Access Compliance Report

Public Rights-of-Way

(Pedestrian Signals)

Intersection ID: N/A	Main Street:	Cross Street: N/A	Location: N/A
ADA ID: 94494ACD1029	Signal Type: One Push Button-Non APS	Overall Compliance: No	Severity Score: BTN 1: N/A BTN 2: N/A No BTN: N/A
Codes/Mitigation Info/Possible Solution		Field Measurements/Component Compliance

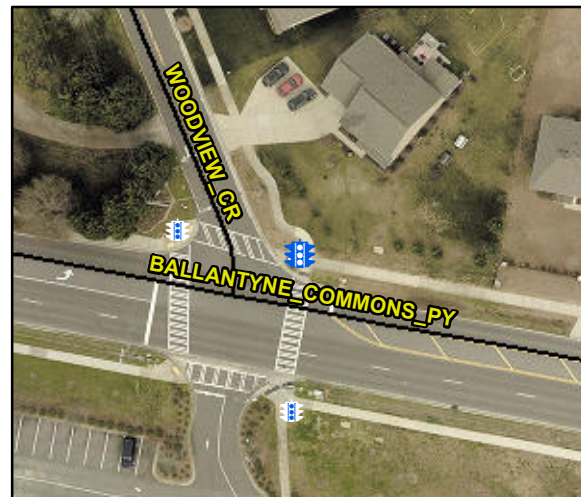
Yes	B 1 Clear Xing Direction?	ClearlyMarked	N/A	B 2 Clear Xing Direction?	N/A
	B 1 Crossing Direction	To S		B 2 Crossing Direction	N/A
Yes	B 1 DistanceTo XWalk (in)	0.0	N/A	B 2 DistanceTo XWalk (in)	N/A
No	B 1 DistanceTo Curb (in)	138.0	N/A	B 2 DistanceTo Curb (in)	N/A
Yes	B 1 Diameter (in)	2.0	N/A	B 2 Diameter (in)	N/A

Possible Solutions: Replace Signal Push Button With APS Button on New Post. Remove & Relocate Sign.

PROW/ADA: TMUTCD 4e.08, R404.2, R404.3, R404.7.3
